UNITED STATES PATENT AND TRADEMARK OFFICE

Office Action Summary

10/765,708

DETAILED ACTION

Modified Fig. 3 – Added reference notations

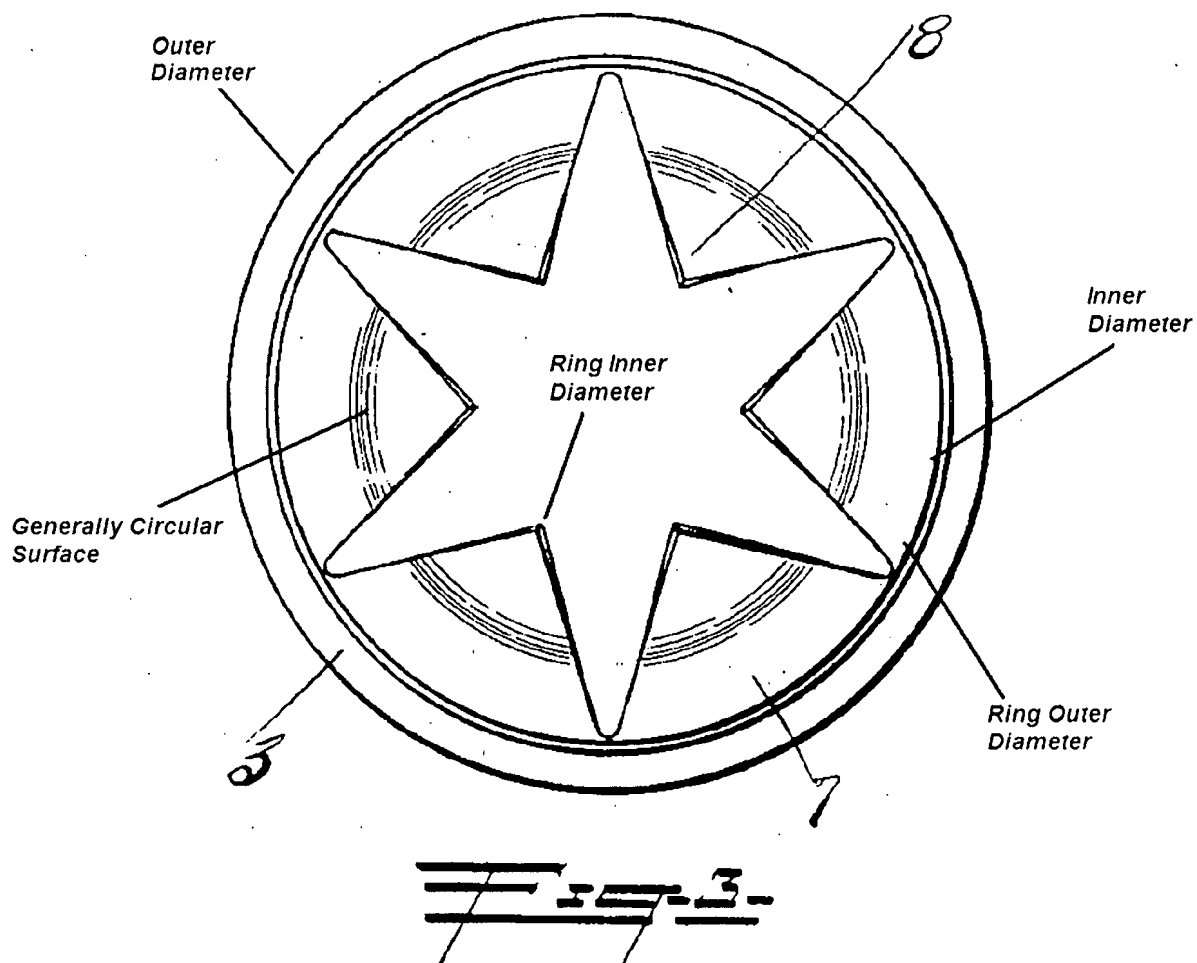
tubular member (Fig. 1, No. 3) having an inner diameter (Modified Fig. 3, Inner Diameter) and two or more rings (Fig. 2, No. 7) located on the inner diameter of the tubular member; each ring having an inner surface (Figs. 3 and 4) exposing directly to an exhaust gas passageway in the tubular member, the rings being configured to provide constriction of the passageway which causes mixing of the cooling water with the exhaust gases to reduce noise generated by the combustion engine (Col. 1, Lines 9-19).

5. With regards to claim 3, Pribil discloses the exhaust assembly of claim 1, as described above, and further wherein the tubular member is flexible (Fig. 1, No. 3) and is configured to be connected between the exhaust manifold and directly to the muffler, each ring having an outer diameter (Modified Fig. 3, Ring Outer Diameter) the same as the inner diameter of the tubular member and an inner diameter (Modified Fig. 3, Ring Inner Diameter) smaller than the inner diameter of the tubular member.

6. With regards to claim 4, Pribil discloses the exhaust assembly of claim 1, as described above, and further wherein the tubular member (Fig. 1, No. 3) is rigid (Fig. 1, No. 3 – Diameter of tube is rigid) and is connectable between the exhaust manifold (Fig. 1, No. 2) and an exhaust hose connected to the muffler (Fig. 1, No. 11 – connectable to anything), each ring having an outer diameter (Modified Fig. 3, Ring Outer Diameter) the same as the inner diameter of the tubular member and an inner diameter (Modified Fig. 3, Ring Inner Diameter) smaller than the inner diameter of the tubular member.

7. With regards to claim 6, Pribil discloses an exhaust apparatus for a marine genset comprising: a flexible exhaust tubular member (Fig. 1, No. 3) configured to be connected between an exhaust manifold (Fig. 1, no. 2) of a combustion engine (Fig. 1, No. 1) and a muffler (Fig. 1, No. 11 – connectable to anything), the flexible exhaust tubular member having an inner diameter (Modified Fig. 3, Inner Diameter); and two or more rings (Fig. 2, No. 7) located on the inner diameter of the flexible exhaust tubular member, each having an outer diameter (Modified Fig. 3, Ring Outer Diameter) the same as the inner diameter of the flexible exhaust tubular member and an inner surface having an inner diameter (Modified Fig. 3, Ring Inner Diameter) smaller than the inner

12. With regards to claim 22, Pribil discloses the exhaust assembly of claim 1, as described above, and further wherein at least one of the rings has a generally circular inner surface (Modified Fig. 3, Generally Circular Surface).

23. Applicant has argued, "Pribil fails to teach or suggest the exhaust tubular member having two or more rings located on its inner diameter and at least one of the rings having a generally circular inner surface". The examiner respectfully disagrees. Figure 3 of Pribil shows the generally circular inner surface of the ring (Fig. 3, No. 7).
